BNFL-5232-RPT-ESH-07, Rev. 0

Construction Certification Report for Waste Management Facility –634 for the Advanced Mixed Waste Treatment Project

Subject: **Transmittal of the Construction Certification Report for the AMWTP Waste Characterization Facility (WMF-634) – AM-BN-L-5176**

TYPE II MODULE (WMF-634) CHARACTERIZATION FACILITY GENERAL ARRANGEMENT

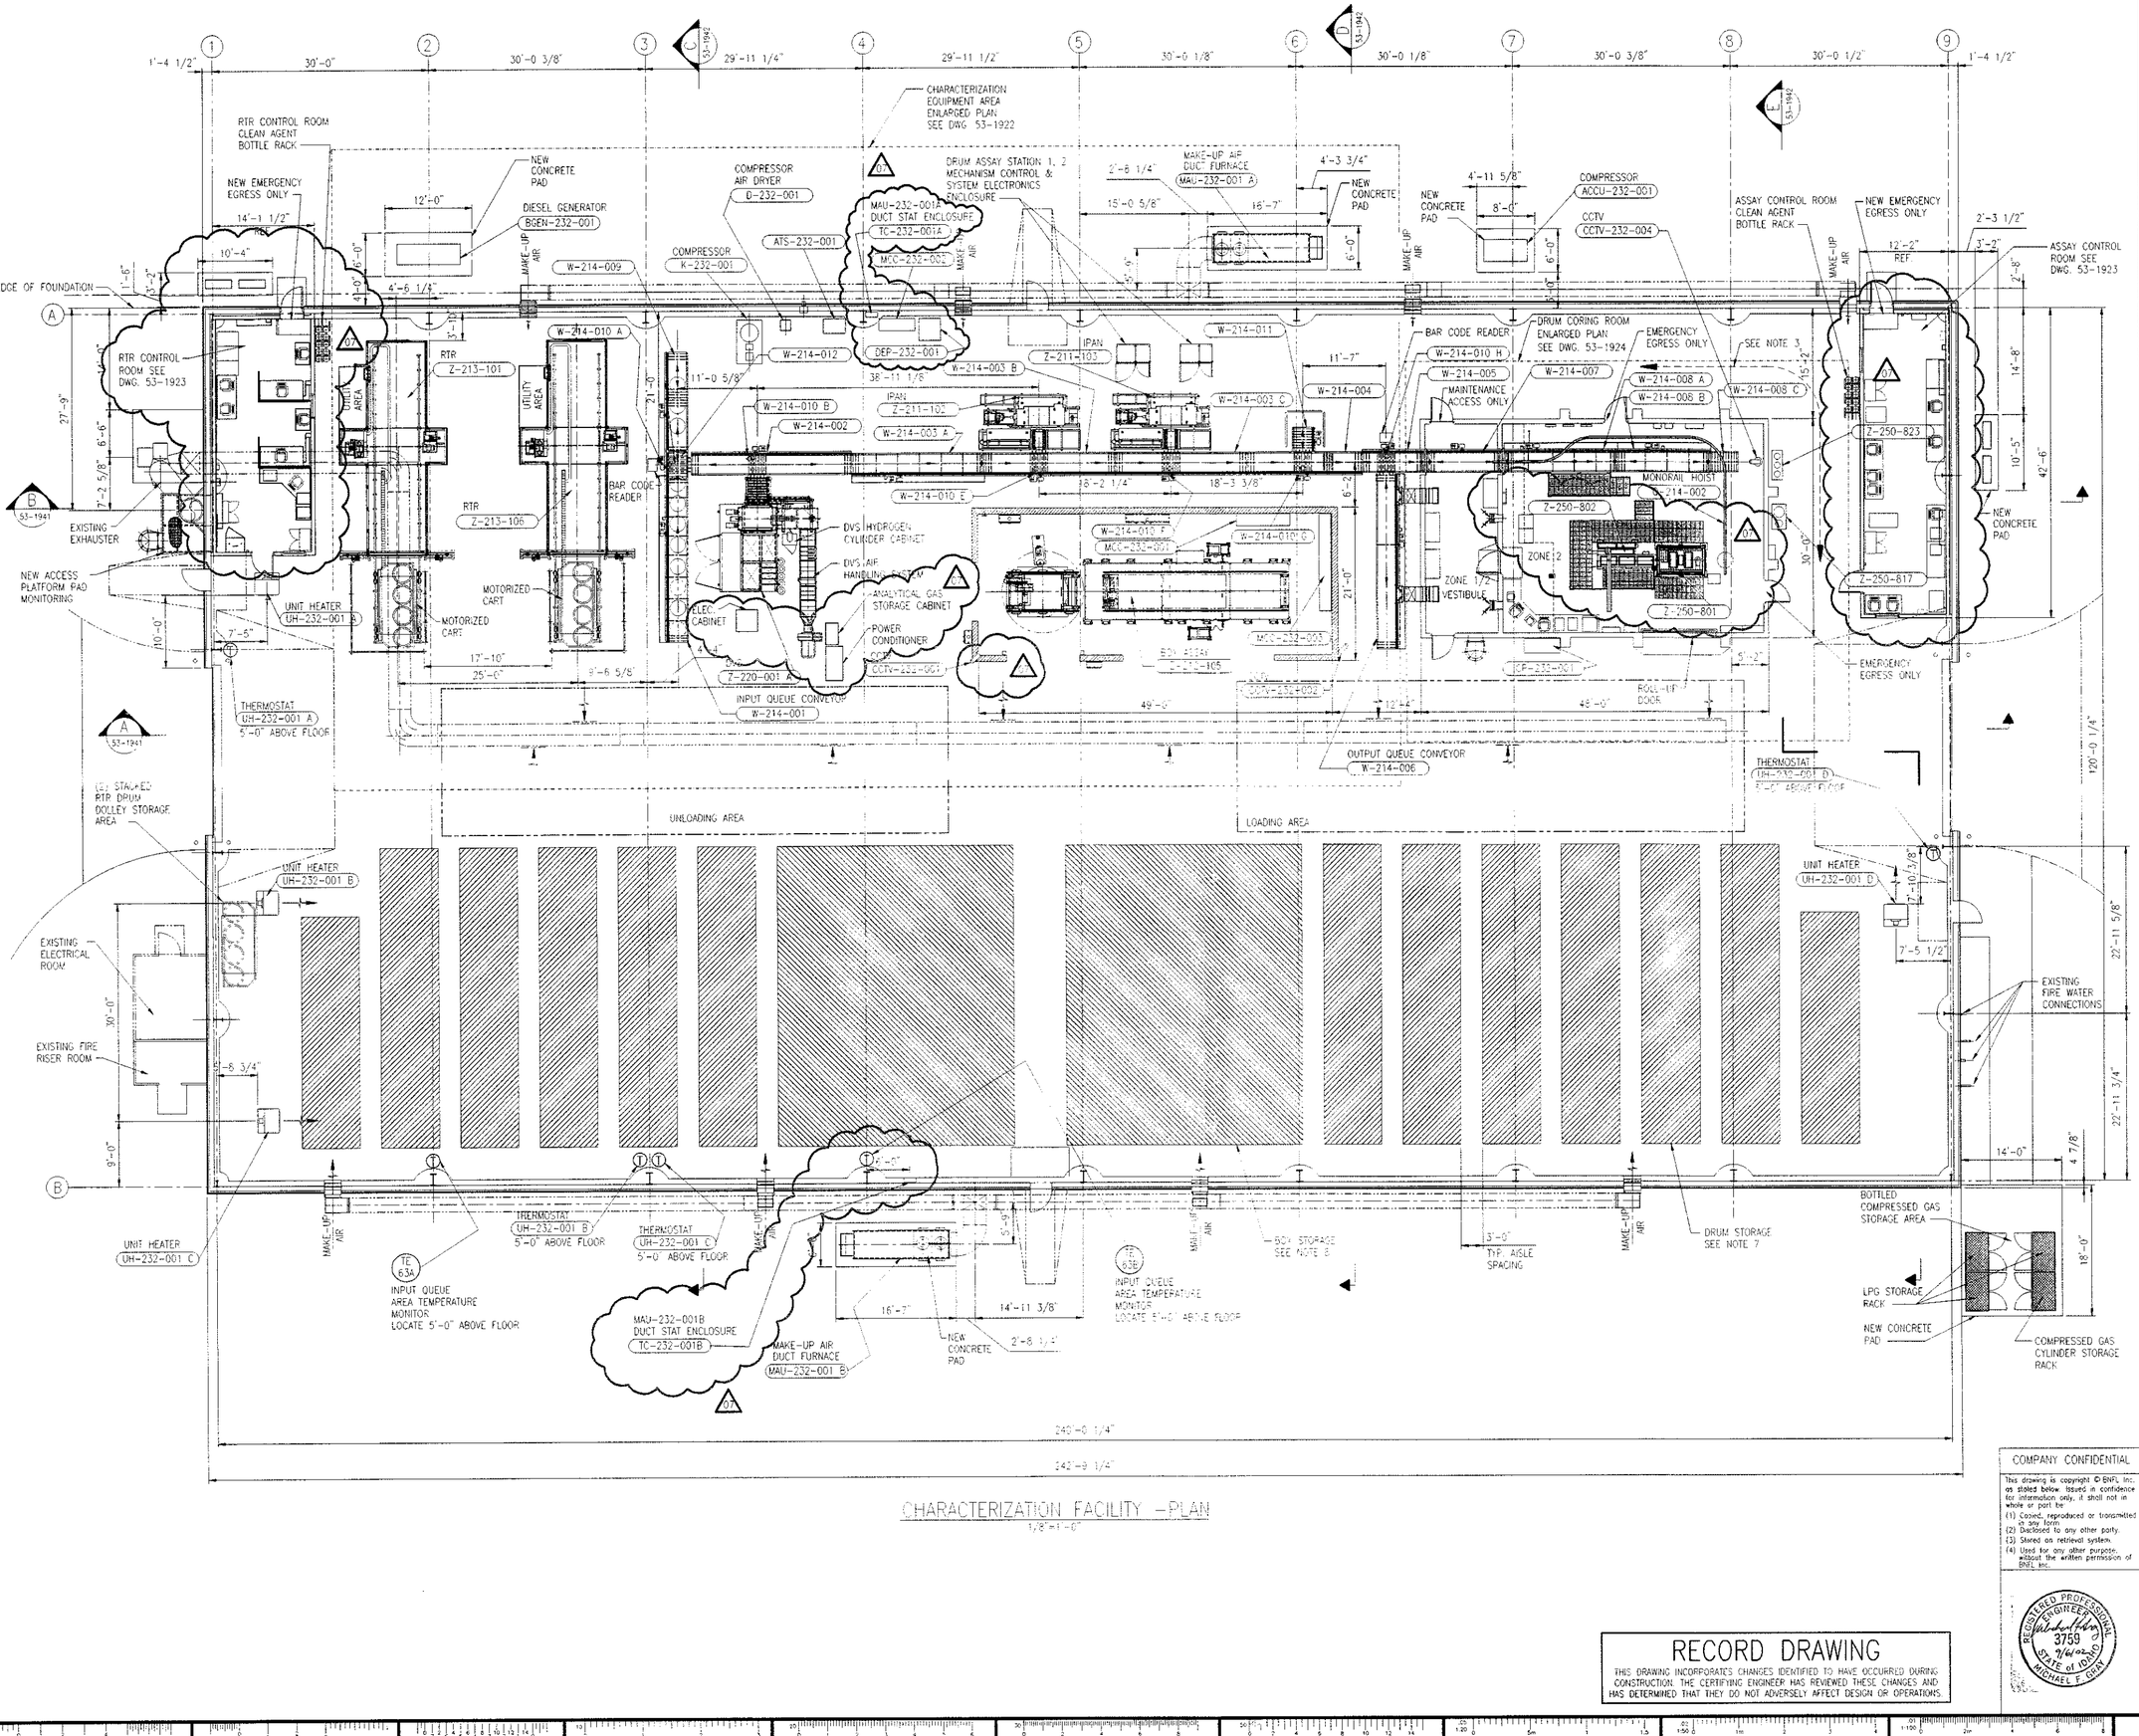
Drawing Number	Revision Number	Minor Deviations To As-Built Drawing[1]	Rational
Type II Module (WMF-634) Characterization Facility General Arrangement			
53-1921	7	The location of the roller conveyor and chain transfer sections located between columns 3 and 4 have been changed from 3 feet (ft) – 11 5/8 inches (in.) and 11 ft – 1 in. to 4 ft – 4 in. and 11 ft - 5/8 in. respectively. The dimensions for these sections of conveyor are located at grid points F7 and F5.	Location of conveyor and transfer chain sections was changed in order for the equipment to be installed properly.
		The location of the roller conveyor and chain transfer sections located between columns 3 and 5 has been changed from 38 ft – 11 in. to 38 ft – 11 1/8 in. The dimension for this section of conveyor is located at grid point H5.	Location of conveyor and transfer chain sections was changed in order for the equipment to be installed properly.

The location of the roller conveyor and chain transfer sections located between columns 4 and 6 has been changed from 18 ft – 5 in. to 18 ft – 2 1/4 in. The dimension for this section of conveyor is located at grid point K6.	Location of conveyor and transfer chain sections was changed in order for the equipment to be installed properly.
		The location of the roller conveyor and chain transfer sections located between columns 5 and 7 has been changed from 18 ft – 6 in. to 18 ft – 3 3/8 in. The dimension for this section of conveyor is located at grid point L6.	Location of conveyor and transfer chain sections was changed in order for the equipment to be installed properly.
		The location of the roller conveyor and chain transfer sections located between columns 6 and 7 has been changed from 11 ft – 8 in. to 11 ft – 7 in. The dimension for this section of conveyor is located at grid point M5.	Location of conveyor and transfer chain sections was changed in order for the equipment to be installed properly.

The orientation and size of the air compressor, equipment identification number (ID No.) K-232-001, was modified. The air compressor is located on the north wall of WMF-634 at grid point F4.	Air compressor modified to facilitate ease of installation and maintenance on air compressor.

Drawing Number	Revision Number	Minor Deviations To As-Built Drawing[1]	Rational
Type II Module (WMF-634) Characterization Facility General Arrangement (continued)			
53-1921	7	The orientation and size of the compressor air dryer, equipment ID No. D-232-001, was modified. The compressor air dryer is located on north wall of WMF-634 at grid point G4.	Compressor air dryer modified to facilitate ease of installation and maintenance on compressor air dryer.
		Updated the general arrangement of Drum Vent System (DVS). Added hydrogen cylinder cabinet, analytical gas storage cabinet, power conditioner, and moved the electrical cabinet 2 ft 6 in. south and 2 ft 1 in. east. The DVS is located at grid point G7.	Updated to accommodate the current vendor design on the DVS.
		Relocated CCTV, equipment ID No. CCTV-232-001, on south west corner of box assay shield wall to approximately 3 ft above the top of the shield wall at the south west corner. The CCTV is located at grid point H7.	The CCTV was relocated to enhance operational efficiencies.

The handrail section, which is located within the box assay shield wall area near column 5, has been removed. The handrail section was located at grid point J6.	The handrail section is no longer required for personnel safety because the shielding has been revised and the access to the box assay equipment is protected by a photocell.
		The drum assay stations (1 and 2) mechanism control and system electronics enclosures were relocated. The enclosures have been moved approximately 3 ft south from the position along the north wall of WMF-634. The enclosures have been separated by approximately 3 ft by moving the east enclosure. The enclosures are located at grid point K5.	Assay stations mechanical control and system electronics enclosures were relocated to facilitate maintenance and installation.
		Relocated the assay control room clean agent bottle rack, used for the inergen clean agent fire suppression system in the assay control room, from the north wall of WMF-634 to the west wall of the assay control room. The bottle rack is located at grid point Q5.	Change made due to insufficient clearance on the north wall of WMF-634 to mount the bottle racks and the pre-action valve train for fire water to the control room.

Relocated the packet assay system approximately 3 ft to the east. Packet assay system located at grid point N6.	Packet assay system moved to facilitate maintenance.

Drawing Number	Revision Number	Minor Deviations To As-Built Drawing[1]	Rational
Type II Module (WMF-634) Characterization Facility General Arrangement (continued)			
53-1921	7	Modified the sampling glovebox, equipment ID No. Z-250-802, to incorporate changes. Changes made to the sampling glovebox include: a) reduction in the width of the sample glovebox from approximately 40.75 in. to 36 in., b) separation of the sampling glovebox into two smaller gloveboxes (i.e., a radiological contaminated side and radiological clean side) each with a width of approximately 18 in., c) modification of glovebox windows from a diamond shape to a rectangle shape, d) installation of additional gloveports into the glovebox, e) installation of various ports and air filters, f) reduction of the sampling glovebox to an approximate length of 48 in. and height of 18 in. and g) addition of ventilation piping to the glovebox. The sampling glovebox is located at grid point O6.	Design changes made to meet operational requirements.

Modified the coring glovebox, equipment ID No. Z-250-801, to incorporate changes. Changes made to the coring glovebox include: a) reduction of the width of the glovebox by approximately 8 in., 2) installation of additional gloveports on the glovebox, 3) changed a portion of the glovebox windows from a diamond shape to a rectangle shape, 4) addition of ventilation piping to glovebox, and 5) deletion of infeed conveyor, equipment ID No. W-250-804. The coring glovebox is located at grid point P6.	Design changes made to meet operational requirements.
		Relocated the Real Time Radiography (RTR) control room clean agent bottle rack, used for the inergen clean agent fire suppression system in the RTR control room, from the north wall of WMF-634 to the east wall of the RTR control room.	Change made due to insufficient clearance on the north wall of WMF-634 to mount the bottle racks and the pre-action valve train for fire water to the control room.

Drawing Number	Revision Number	Minor Deviations To As-Built Drawing[1]	Rational
Type II Module (WMF-634) Characterization Facility General Arrangement (continued)			
53-1921	7	Moved the location of the personnel access stairs to the platform of the coring and sampling gloveboxes was moved from the north east side of the platform to the central area of the north side of the platform. Modified the orientation of the personnel access platform. The personnel access platform is located at grid point O7.	Design changes made to meet operational requirements.
		Revised equipment layout in RTR and Assay Control Rooms. RTR Control Room is located at grid point B5 and Assay Control Room is located at Q5.	Design changes made to meet operational requirements.
		Relocated temperature controls for MAU-232-001A and 001B to inside WMF-634 near column line 4 on the north and south walls respectively. Added equipment labels for temperature controllers, TC-232-001A and 001B. Equipment ID No. labels located at H3 and F14 respectively.	The temperature controls were moved to enhance operational efficiencies.

Relocated the pneumatic panel from the south west wall of the inner box assay shield wall (grid point J8) to the north wall of the inner box assay shield wall (grid point J6).	Pneumatic panel relocated per vendor specifications.
		Added box assay operator interface panel to the outer south wall of the box assay shield wall. Control panel located at grid point K8.	Equipment provided for completeness.
		Deleted the packet assay compressor, equipment ID No. P-250-800, which was located at grid point N6.	Packet assay supplied with compressor by vendor.
		Added assay control panel, equipment ID No. DEP-232-001, to the north wall of WMF-634. Panel located at grid point H4.	Equipment provided for completeness.
		Relocated the condensate collection system approximately 3 ft to the east. Condensate collection system located at grid point N6.	Condensate collection system was inadequate for the volume of condensate generated, and was redesigned to increase the capacity of the system. Condensate collection system relocated to accommodate the increase in size.

TYPE II MODULE (WMF-634) CHARACTERIZATION FACILITY SECTIONS SHEET 1

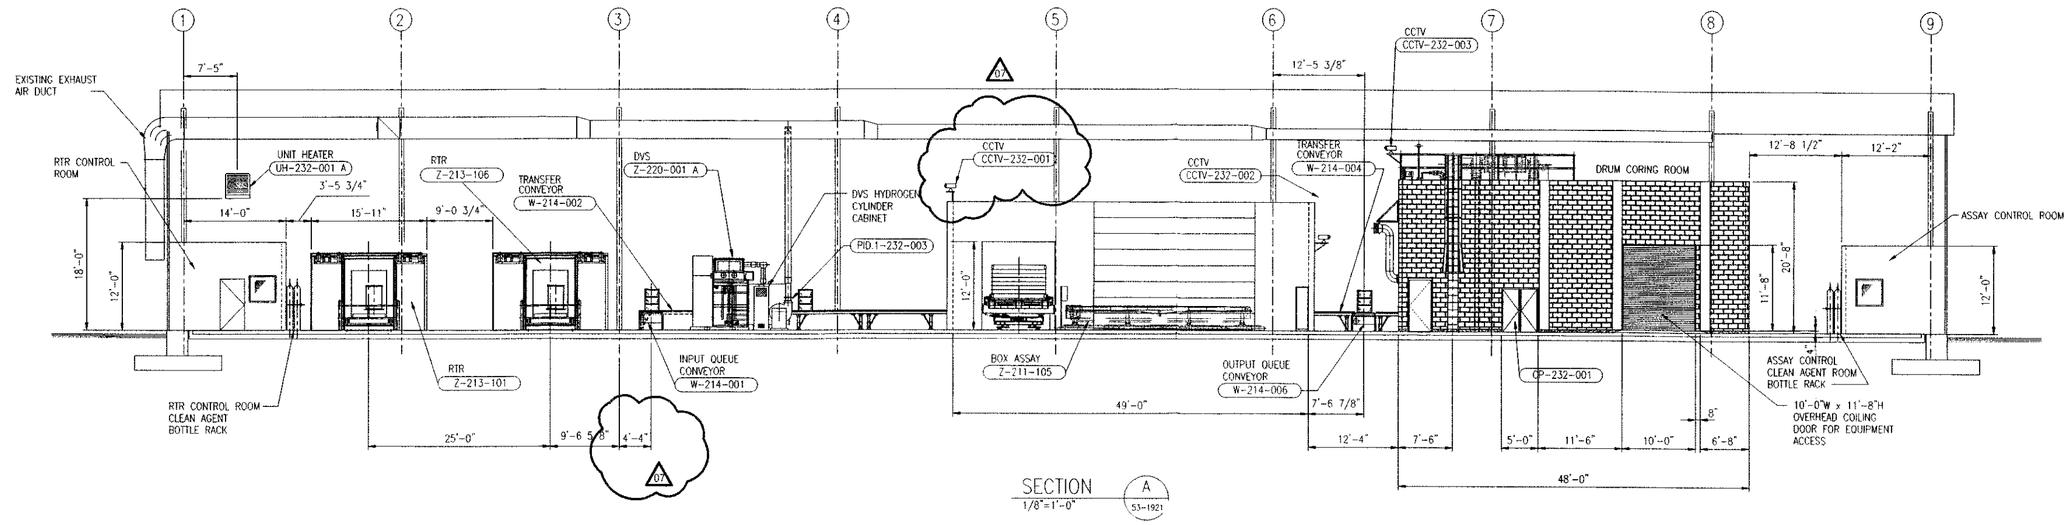
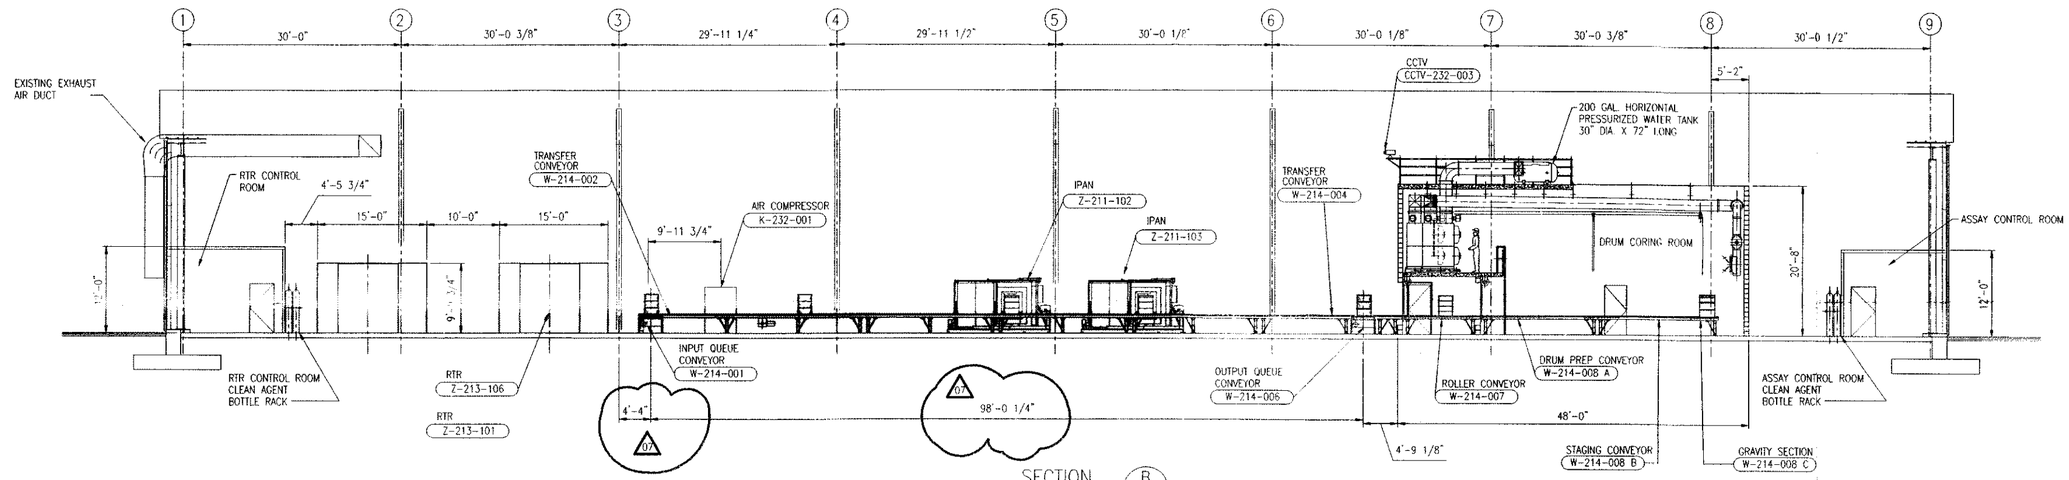
Drawing Number	**Revision Number**	**Minor Deviations To As-Built Drawing[1]**	**Rational**
Type II Module (WMF-634) Characterization Facility Sections Sheet 1			
53-1941	7	Relocated the assay control room clean agent bottle rack, used for the inergen clean agent fire suppression system in the assay control room, from the north wall of WMF-634 to the west wall of the assay control room.	Relocated clean agent bottle rack due to insufficient clearance on the north wall of WMF-634 to mount the bottle racks and the pre-action valve train for fire water to the control room.
		Relocated the RTR control room clean agent bottle rack, used for the inergen clean agent fire suppression system in the RTR control room, from the north wall of WMF-634 to the east wall of the RTR control room.	Relocated clean agent bottle rack due to insufficient clearance on the north wall of WMF-634 to mount the bottle racks and the pre-action valve train for fire water to the control room.

The location of the roller conveyor and chain transfer sections located between columns 6 and 7 for the SECTION A viewpoint has been changed from 12 ft – 6 1/8 in. to 12 ft - 5 3/8 in. The dimension for this section of conveyor is located at grid point M2 on the drawing.	Location of conveyor and transfer chain sections was changed in order for the equipment to be installed properly.
		The location of the roller conveyor and chain transfer sections located between columns 6 and 7 for the SECTION A viewpoint has been changed from 7 ft – 7 5/8 in. to 7 ft – 6 7/8 in. The dimension for this section of conveyor is located at grid point M5 on the drawing.	Location of conveyor and transfer chain sections was changed in order for the equipment to be installed properly.
		The location of the roller conveyor and chain transfer sections located between columns 3 and 7 for the SECTION B viewpoint has been changed from 98 ft – 5 5/8 in. to 98 ft 1/4 in. The dimension for this section of conveyor is located at grid point J9.	Location of conveyor and transfer chain sections was changed in order for the equipment to be installed properly.

Drawing Number	Revision Number	Minor Deviations To As-Built Drawing[1]	Rational
Type II Module (WMF-634) Characterization Facility Sections Sheet 1 (continued)			
53-1941	7	The location of the roller conveyor and chain transfer sections located between columns 6 and 7 for the SECTION B viewpoint has been changed from 4 ft – 8 1/8 in. to 4 ft – 9 1/8 in. The dimension for this section of conveyor is located at grid point N10.	Location of conveyor and transfer chain sections was changed in order for the equipment to be installed properly.
		The location of the roller conveyor and chain transfer sections located between columns 3 and 4 for the SECTION A viewpoint has been changed from 3 ft – 11 5/8 in. to 4 ft – 4 in. The dimension for this section of conveyor is located at grid point F5.	Location of conveyor and transfer chain sections was changed in order for the equipment to be installed properly.

The location of the roller conveyor and chain transfer sections located between columns 3 and 4 for the SECTION B viewpoint has been changed from 3 ft – 11 5/8 in. to 4 ft – 4 in. The dimension for this section of conveyor is located at grid point F9.	Location of conveyor and transfer chain sections was changed in order for the equipment to be installed properly.
		Relocated CCTV, equipment ID No. CCTV-232-001, at south west corner of box assay shield wall to approximately 3 ft. above top of south west corner of assay shield wall.	The CCTV was relocated to enhance operational efficiencies.
		Added "Record Drawing" Stamp to drawing.	Information provided for completeness.
		The revision boxes have been updated. This included updating the revision number, revision date, revision description, and approvals.	Information provided for completeness.
WMF-634 Facility Arrangement and Grading Plan			
52-1900	5	The bottled gas storage pad was moved approximately 43.5 ft south along the east wall of WMF-634. The storage pad is located at grid point Q11. Added grading elevation references to the new location of the storage pad. A concrete walkway was added on the east side of WMF-634. Walkway extends from personnel access door to gas storage pad.	Bottled gas storage pad was relocated to increase personnel safety, as the original storage cabinet location was too close to the east WMF-634 personnel access door.
